# Access Compliance Report

## Public Rights-of-Way

### (Curb Ramps)

Intersection ID: 50585	Main Street: GRAND_FIR_RD	Cross Street: BENDING_BRANCH_RD	Location: NW
ADA ID: 790FE433EC04	Ramp Type: Perp	Initial Pass/Fail: Fail	Overall Compliance: No
Severity Score: 21.25			
Codes/Mitigation Info/Possible Solution		Field Measurements/Component Compliance

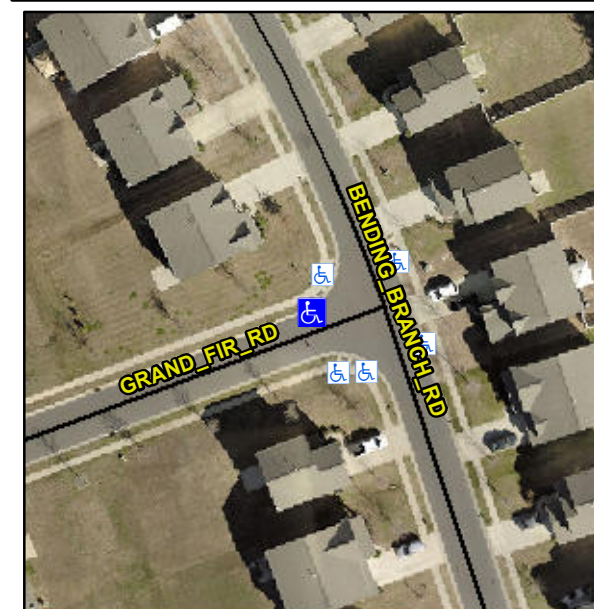
**Not Found, R304.5.1, R304.2.2**

Compliance	Description	Data	Compliance	Description	Data
N/A	Ramp Length (in)	49.5	No	Ramp Slope (%)	11.2
No	Ramp Width (in)	46.5	Yes	Ramp XSlope (%)	1.0
N/A	Flare Type LT	N/A	N/A	Flare Type RT	N/A
N/A	Flare Slope LT (%)	N/A	N/A	Flare Slope RT (%)	N/A
N/A	Flare Traversable LT?	N/A	N/A	Flare Traversable RT?	N/A
N/A	Landing Length (in)	N/A	N/A	DWS Provided?	N/A
N/A	Landing Width (in)	N/A	N/A	DWS Contrast?	N/A
N/A	Landing Slope (%)	N/A	N/A	DWS Length (in)	N/A
N/A	Landing X Slope (%)	N/A	N/A	DWS Full Width?	N/A
N/A	Landing Curb? (Y/N)	N/A	N/A	DWS Offset (in)	N/A
N/A	Shared Landing?	N/A			
N/A	Gutter Ponding?	N/A	N/A	Gutter Slope (%)	N/A
N/A	Gutter Lip Ht (in)	N/A	N/A	Gutter X Slope (%)	N/A
N/A	Painted X Walk1?	No	N/A	Painted X Walk2?	N/A
	X Walk 1 Direction	To S		X Walk 2 Direction	N/A
N/A	X Walk 1 Width (in)	N/A	N/A	X Walk 2 Width (in)	N/A
	X Walk 1 Slope (%)	2.2		X Walk 2 Slope (%)	N/A
	X Walk 1 X Slope (%)	1.2		X Walk 2 X Slope (%)	N/A

**Remove & Replace Entire Ramp.**
